**Subject:** AES HBEP - Response to E-Mail Request from CEC Staff on Use and Number of Stories for Specific HBEP Building

Informal E-Mail Request: From Lisa Worrall CEC – January 17, 2013

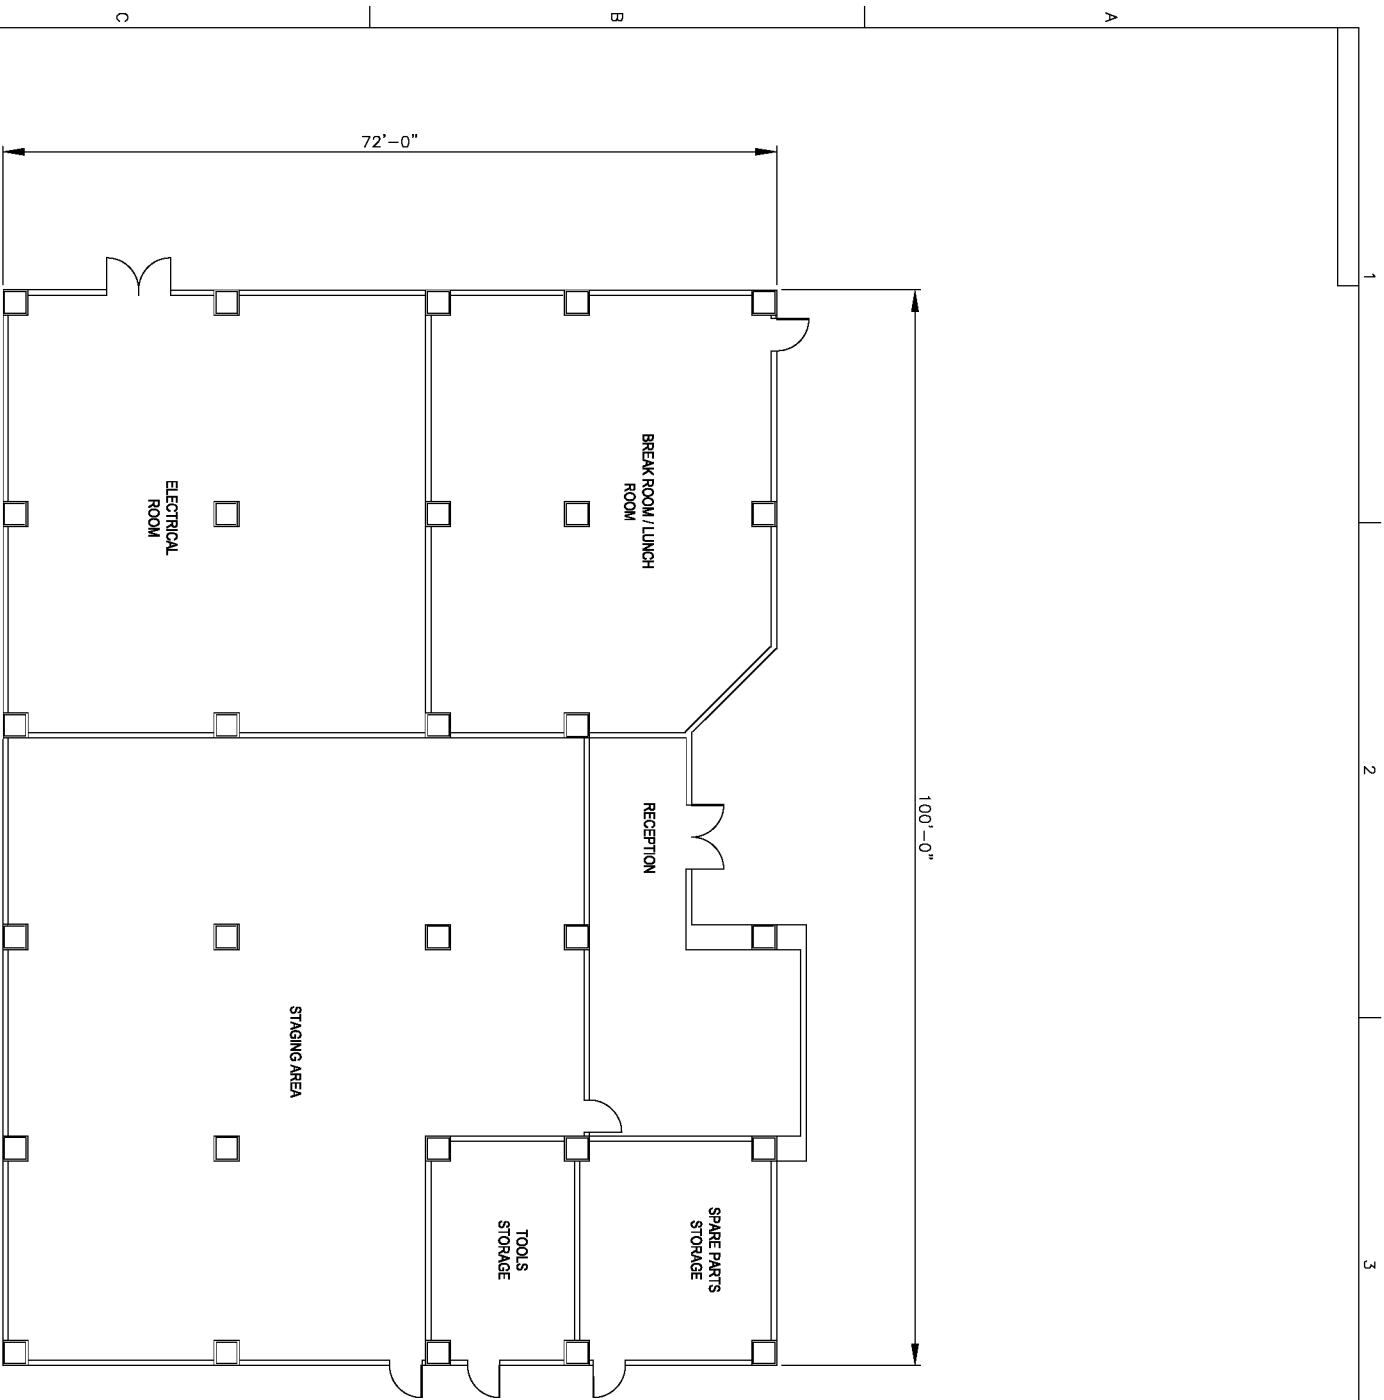
*Specifically, on Figure 2.1-1 General Arrangement/Site Plan of the AFC, how many stories are No. 32, 33, 34, and 37 are on the Equipment List? (The actual building heights are listed, but a 35' warehouse might be one story, whereas a 40' admin building might be 4 stories.) Also for No. 32, what does "RO/EDI" building stand for? Thank you, Lisa Worrall*

Existing Building No. 32 – RO/EDI (reverse osmosis/electro-deionization) Building (Reuse) is a single story water treatment system building the existing HBGS that produces high quality industrial water for onsite use. As noted on Figure 2.1-1 General Arrangement/Site Plan from the AFC, this facility will be used to produce high quality industrial water for HBEP. This building houses equipment only and does not include administrative space.
